## Rejection of Biala LVIA

The LVIA complies with neither the terms nor the spirit of the SEARs issued for Biala wind farm and should be rejected with a stern warning that this is culpable behaviour.

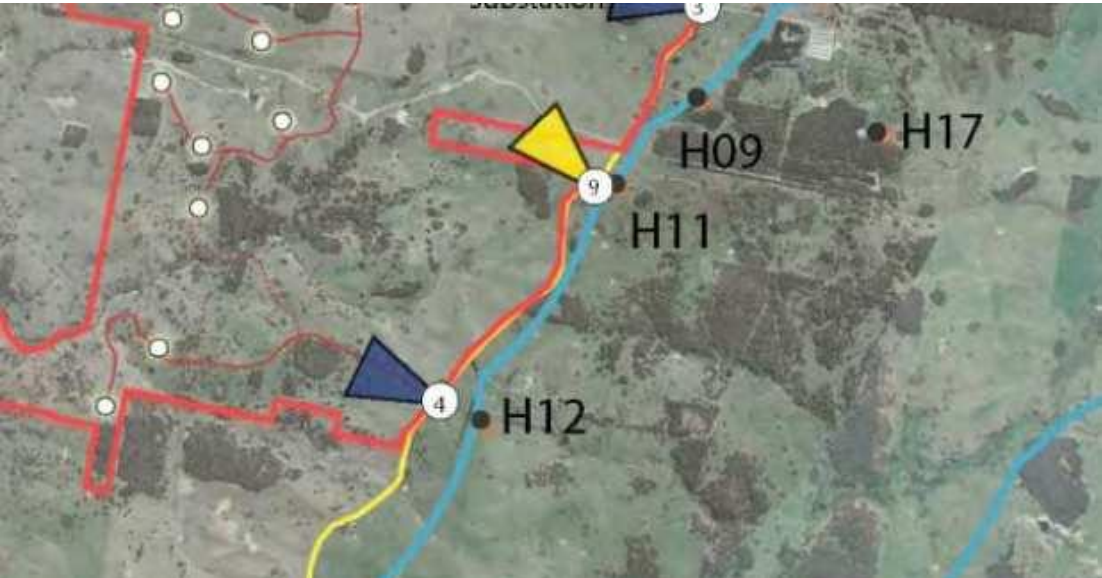
Did Newtricity include photomontages from (all) potentially affected residences? – NO, only from a few sample residences.

Did Newtricity include photomontages from all non-host dwellings within 2km? – YES, because apparently there are none (although the nearest turbine to viewpoint 9 is listed as 1.9km [page 63, LVIA])

Let us look at residence H09.

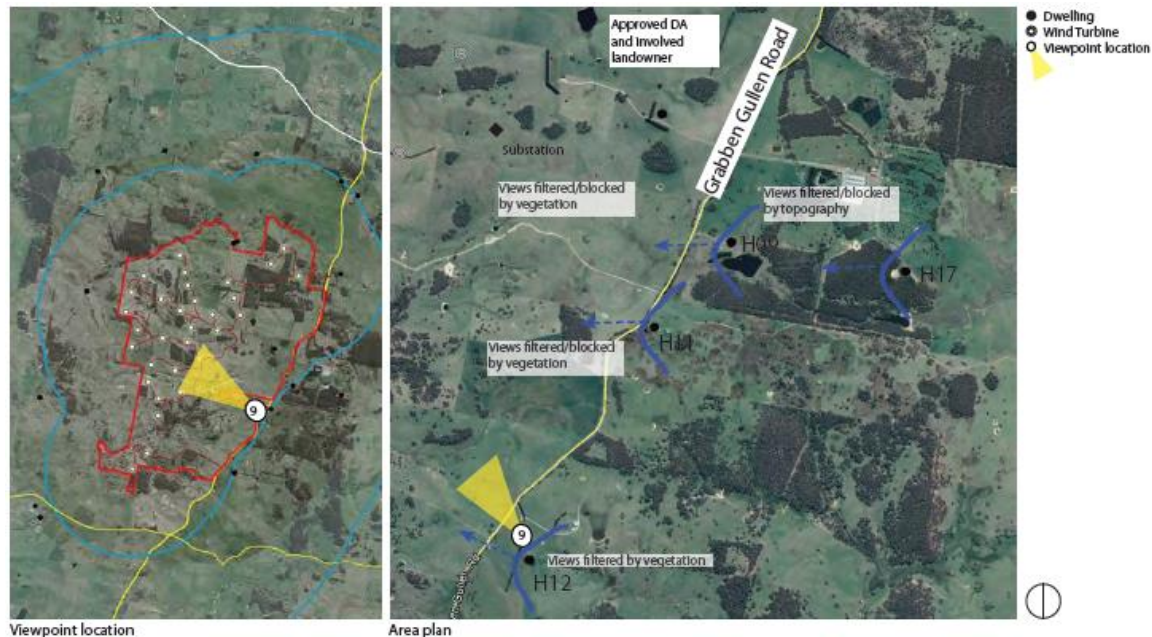
There it is. “surrounded by tree planting”

Once again, neither we nor the Department will be able to judge the visual impact from this residence. There is no photomontage. We could guess, with 185 metre tall turbines, 2 kilometres to the west, that the impact could be EXTREME.

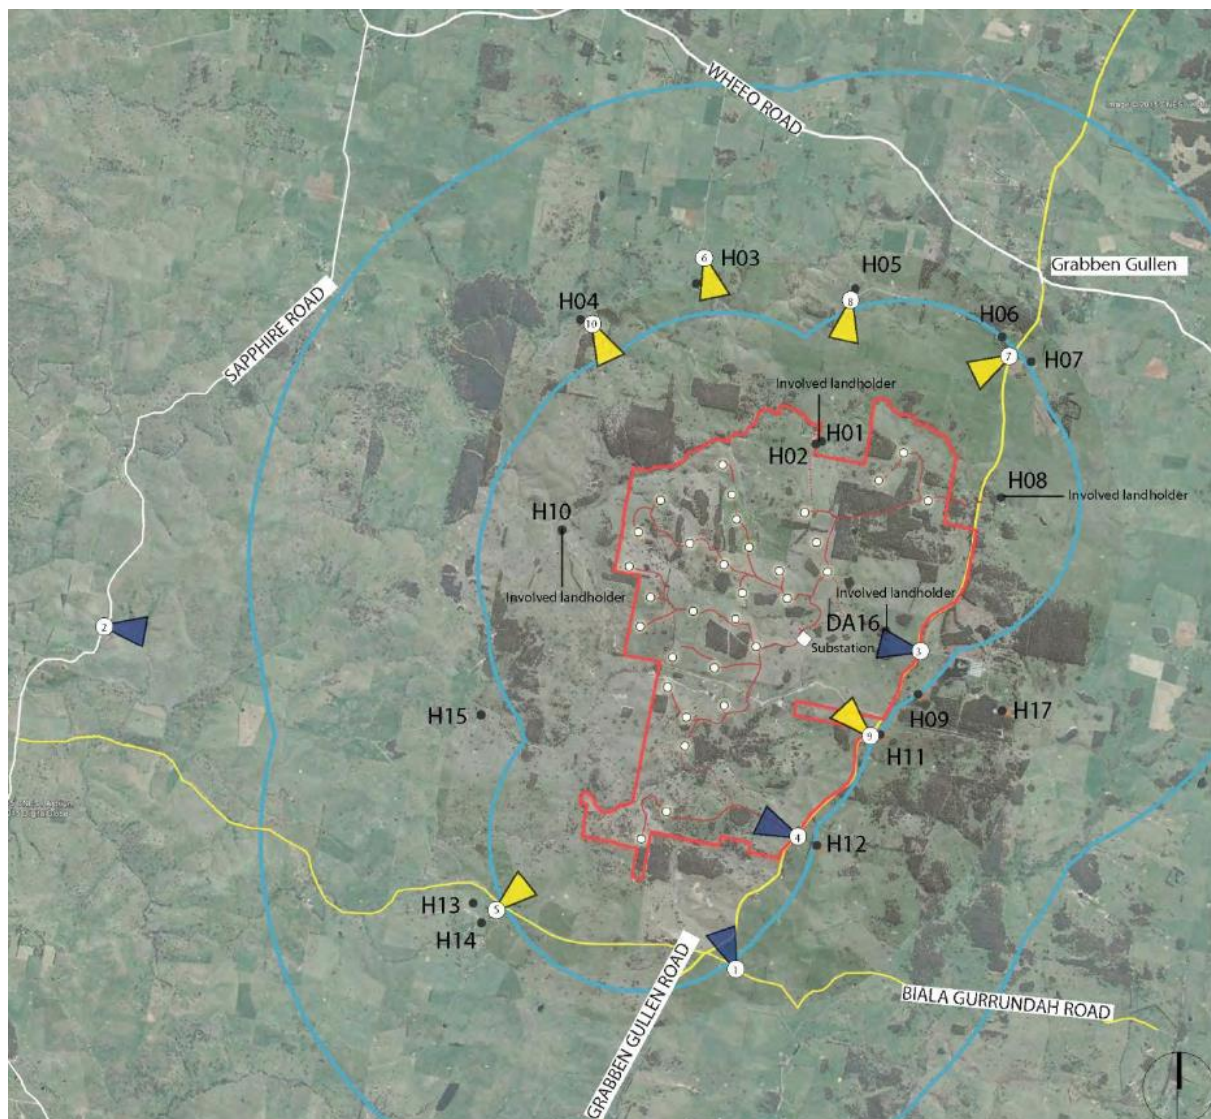
And then the confusion further increases. The Newtricity consultants, ERM and Clouston Associates (CA) agree on the location of the 10 viewpoints (See Appendix A). CA has postulated the visual impact from these viewpoints, 6 of which were private (numbered 5 to 10).

Figure 13 - Photomontage locations

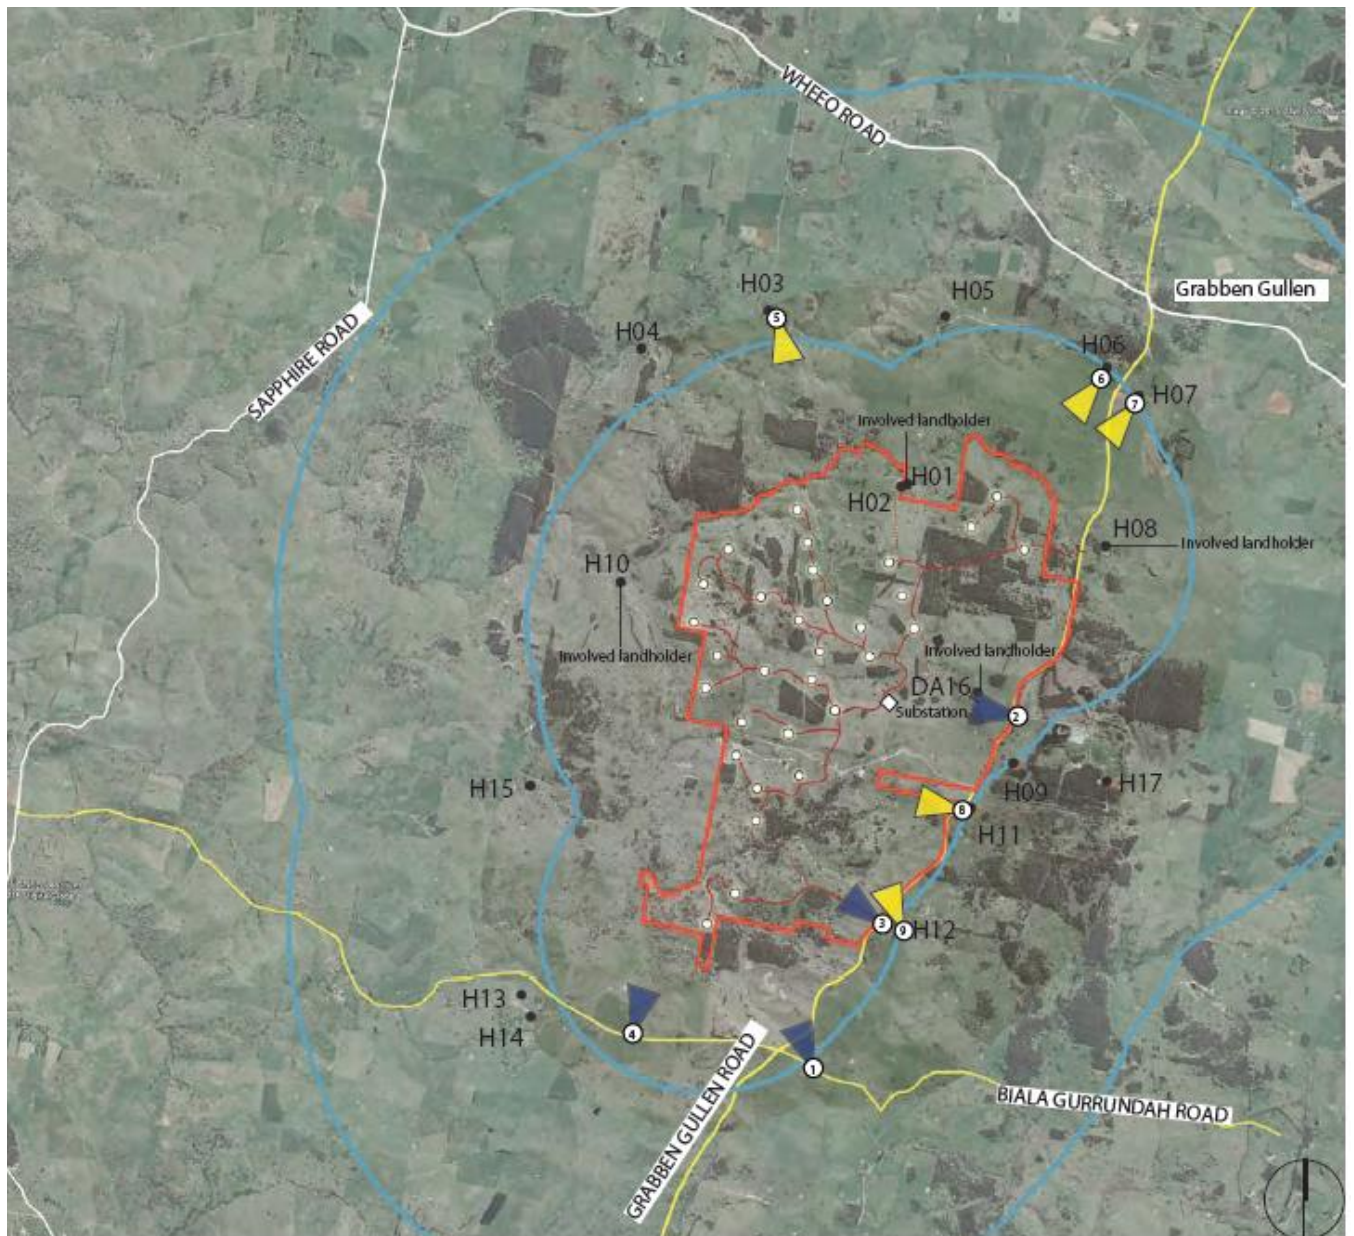
Considering the private photomontages only. Refer Figure 13, Page 90, Photomontage locations. (See Appendix B)

- No photomontage was published (produced?) from viewpoint 10.
- Photomontage 5 was taken from viewpoint 6.
- No photomontage was published (produced?) from viewpoint 8.
- Photomontages 6 and 7 were taken from somewhere near viewpoint 7
- Photomontage 8 was taken from viewpoint 9
- Photomontage 9 was taken from somewhere near **public** viewpoint 3
- No photomontage was published (produced?) from viewpoint 5.

5 private photomontages in total, from somewhere near 3 of the 6 private viewpoints.

We cannot understand how CA assessed 6 private viewpoints from these photomontages.  
Can the Department?
